Technical Service Bulletin

MODEL(S) AFFECTED: B5 propel, B7, T300/e propel, T500/e, T600/e, SpeedGleam 5 propel, SpeedGleam 7, Speed Scrub 300 propel and Speed Scrub 500
N. America models manufactured before April 12, 2021.

SUBJECT: Speed Control potentiometer failure. Over time, under normal operating use, the potentiometer may exhibit a brief open-circuit condition and cause a propel fault. The detected fault will automatically put the i-Drive in the slow, safe mode or even cause complete propel failure. A simple key-cycle may clear the fault temporally, however the fault can reoccur when adjusting speed dial.

New Replacement Potentiometer p/n 1256757

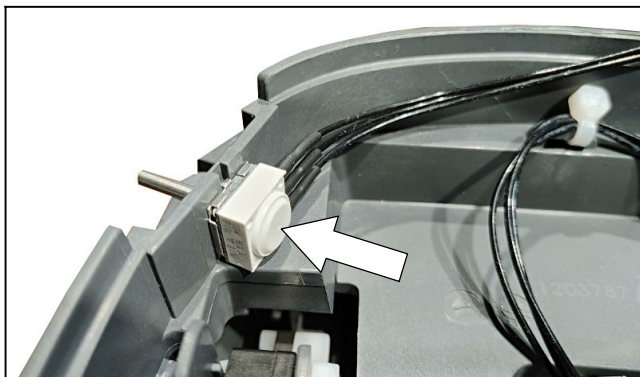
PURPOSE: To repair potentiometer, order replacement potentiometer (p/n 1256757). The new potentiometer is designed with a ceramic-based resistance element for long term durability. It's also designed without speed setting detents, therefore the speed control dial will feel different to the operator.

The new potentiometer is a direct replacement and does not require any specific installation instructions. To identify the difference between the previous potentiometers, the body on the new potentiometer is thinner.

Previous Potentiometers (Discontinued)

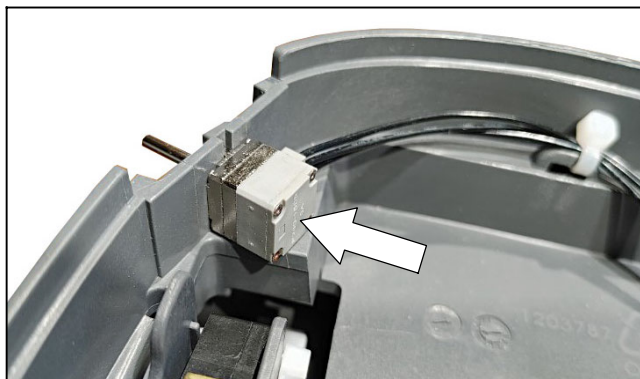
NOTES: **Warranty Information:** Standard warranty terms apply. If you have any existing inventory of the previous potentiometers, it is advised to scrap them out and reorder the new replacement part.
